DUKE COGEMA  
STONE & WEBSTER

12 February 2004  
DCS-NRC-000164

Subject: Docket Number 070-03098  
Duke Cogema Stone & Webster  
Mixed Oxide Fuel Fabrication Facility (MFFF), Response to  
Questions on the Criticality Validation Report – Revision 3 of Part II

**Response to Remaining NRC Questions on:  
Validation Report for AOA3 and AOA4  
Enclosure with DCS-NRC-000164**

**Figure 1. Neutron spectra comparison between PCM002-06 and MFFF typical design application**

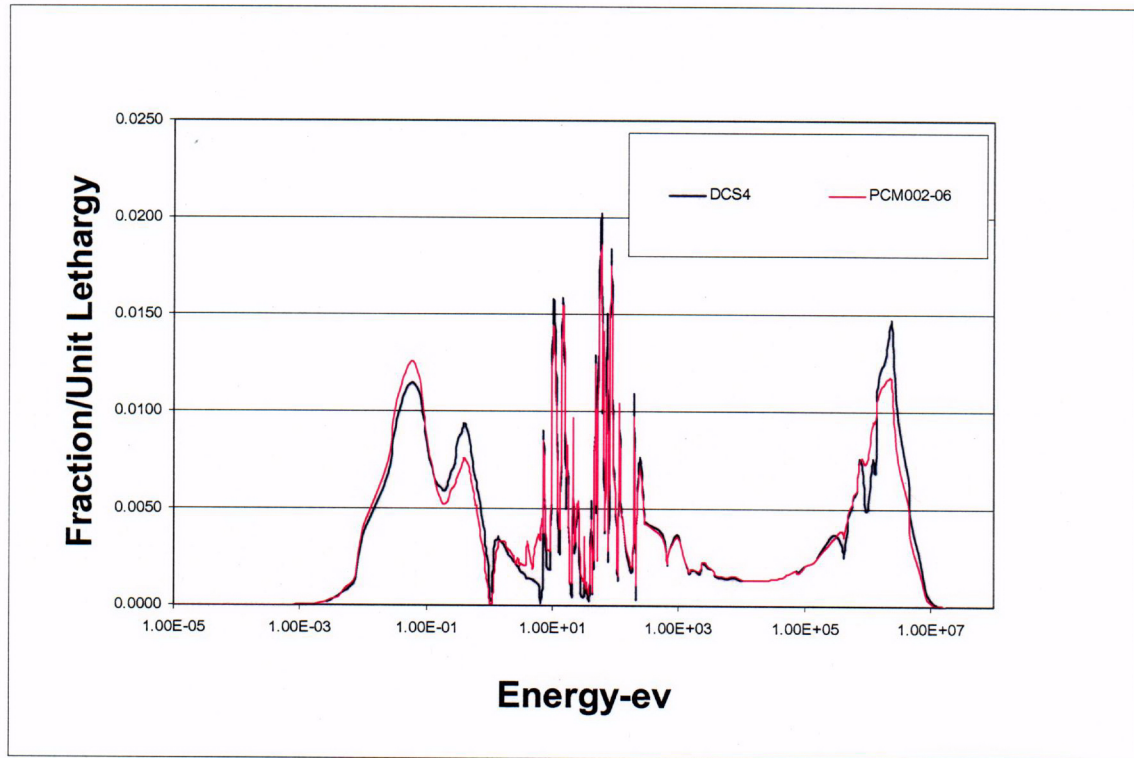
Address the following differences between anticipated design applications and the various sets of benchmark experiments for AOA(4). Explain why systems that are so physically dissimilar in terms of geometric configuration and material composition can be judged to be similar based only upon comparison of the fission spectra.

PCM002: Benchmark models contain H/(U+Pu) ratio and Pu content outside the screening criteria.

This set of 17 experiments has been included in AOA(4) because, while the cases do not meet the H/(Pu + U) and wt. % PuO<sub>2</sub> ranges, they are neutronicallly very similar to AOA(4) design applications. This is illustrated by the similarity of the energy causing fission and the resonance location which are illustrated in Figure 1. Figure 1 gives a comparison of the neutron spectra causing fissions for a typical AOA(4) design application and Case 6.

As seen in Figure 1, in both cases the neutron spectra causing fissions are essentially identical with similar fissions occurring throughout the low, intermediate and high energy ranges providing additional justification for the applicability of this experiment to AOA(4).

Furthermore, the  $k_{\text{eff}}$  from both the benchmark set as well as the design applications are dominantly based on the  $^{239}\text{Pu}$  fissions. To demonstrate this, the 22% Pu content typical design application DCS4, shown in Figure 1, was re-run with the number densities of the uranium set to zero. The  $k_{\text{eff}}$  only went up 2.18% (from 1.0010 to 1.0228) showing that about 98% of the  $k_{\text{eff}}$  was the result of  $^{239}\text{Pu}$  fissions.

As seen, the effect of adding depleted uranium oxide is less than approximately 5%, showing that fissions from  $^{239}\text{Pu}$  dominate and thus a comparison of the fission spectra as shown in Figure 1 is appropriate.

The impact of slightly different H/(Pu+U) between that of the benchmarks and that of the desired validation range is indicative mainly of differences in the relative amount of hydrogen. The relative amount of hydrogen affects thermalization which, in turn, affects energy spectra. However, as can be seen in Figure 1, the energy spectra for this set is similar to that of the design applications. Hence, to the extent that differences in neutron moderation have the potential to affect the spectral properties of the problem, no such impact is observed in the important comparison of fission spectra.

As is noted above in the text and demonstrated in Figure 1, the fissile material in this set is plutonium oxide experiments are closely matched to the fissile material in AOA(4). Hydrogen is contained in the polystyrene moderator for this set matching the hydrogen moderator in the AOA(4) MFFF materials.

Figure 2. Neutron spectra comparison between Pu-8-1 and MFFF typical design application

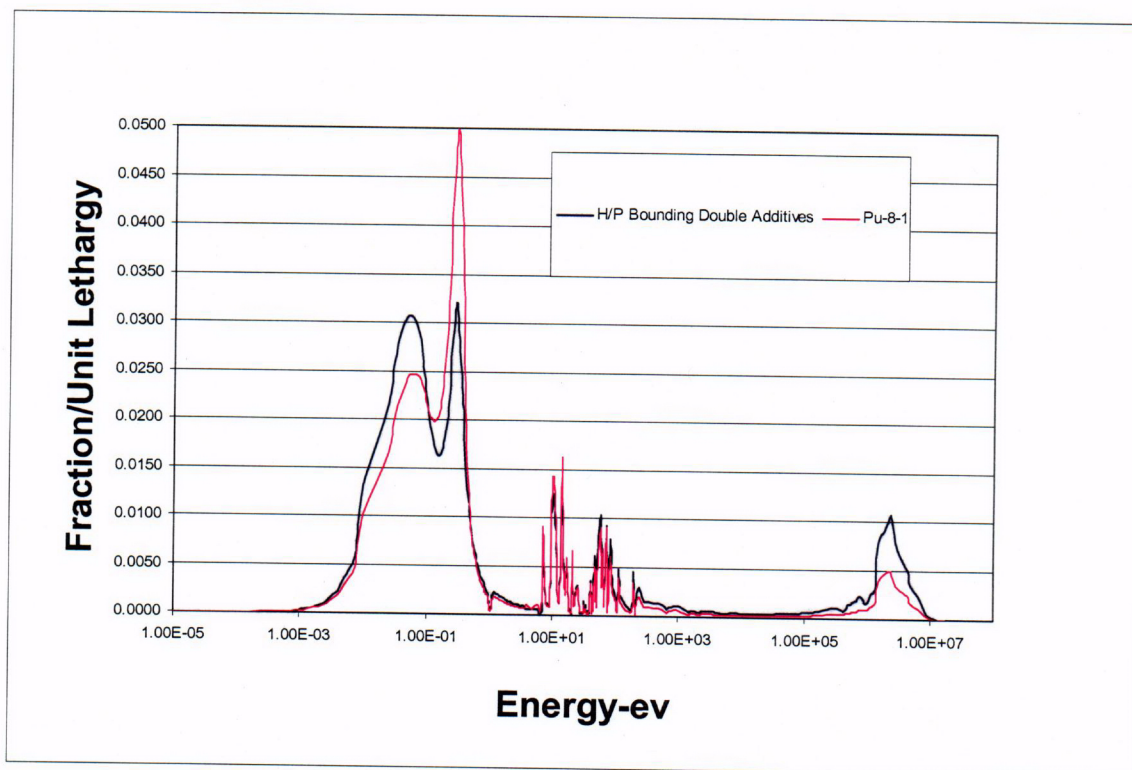
PU-8: Benchmark models contain H/(U+Pu) outside the screening criteria.

While this set is not completely within the desired validation range for AOA(4) due to the H/(Pu + U) values, the other parameters are in range. In particular, the Pu content of this set, about 8%, is very close to the bounding Pu content analyzed in the MFFF of 6.3%.

The impact of the H/(Pu+U) value (7.33) as compared to the screening range (3.84) and application values (1.1-1.6) is that the relative amount of hydrogen is greater than that in the design application. An increase in the relative amount of hydrogen affects the neutron spectrum and results in increased thermalization.

However, a comparison of the neutron spectrum causing fission between this benchmark set and a typical AOA(4) design application, involving final 22% MOX blend, (homogenizer/pelletizer with a bounding double amount of additives) shows (Figure 2) similar behavior.

As seen in Figure 2, in both cases the neutron spectra causing fissions are essentially identical in shape with similar fissions occurring throughout the low, intermediate and high energy ranges providing additional justification for the applicability of this experiment to AOA(4).
